Cortina Systems® LXT973 10/100 Mbps Dual-Port Fast Ethernet PHY Transceiver

Specification Update

20 March 2007

Revision 10.0

Item 9: Detection of Illegal Symbols After SSD

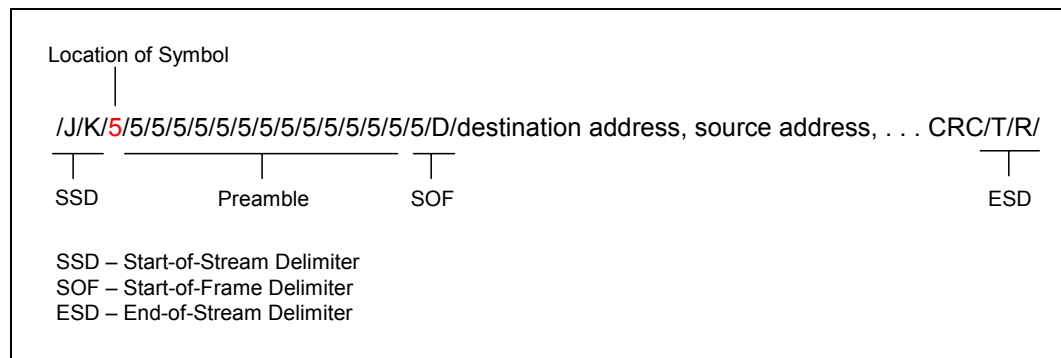
Problem An illegal symbol placed immediately after the Start-of-Stream Delimiter (SSD) (preamble after JK) is not detected. However, any subsequent corrupt symbol will be detected.

Implication RXER will not assert if this symbol location is corrupted. However, an error in this location does not affect packet integrity.

Workaround Use the MAC layer protocol to detect corrupt symbols in the packet.

Figure 4 Ordering Information – Sample

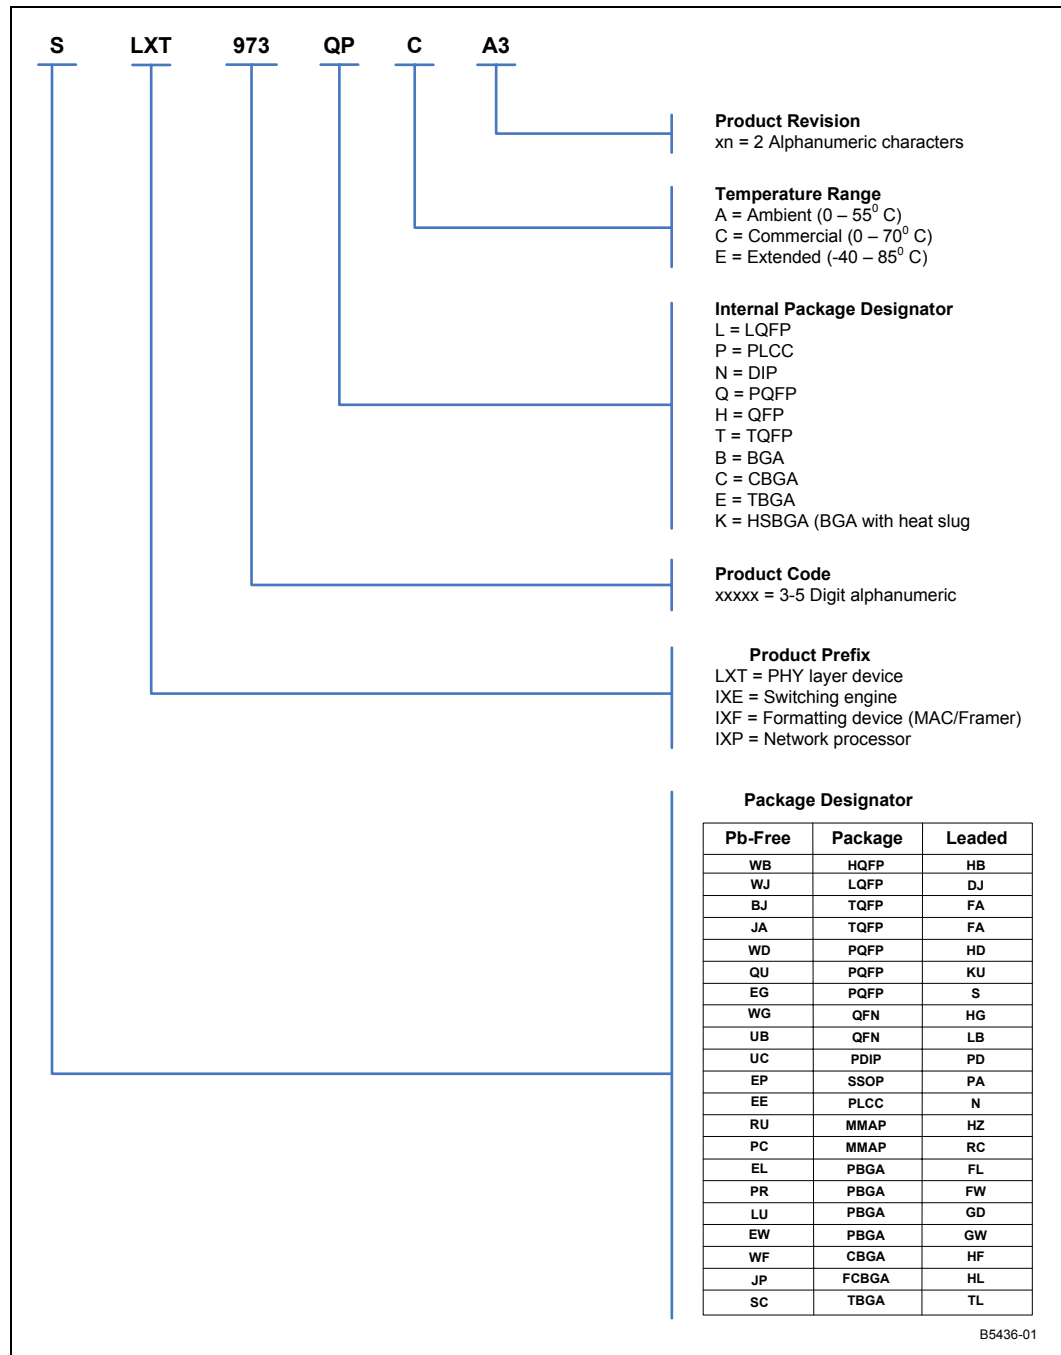
Item 1: Product Ordering Information

Table 3 lists the LXT973 PHY Transceiver product ordering information. Figure 4 provides the ordering information matrix.
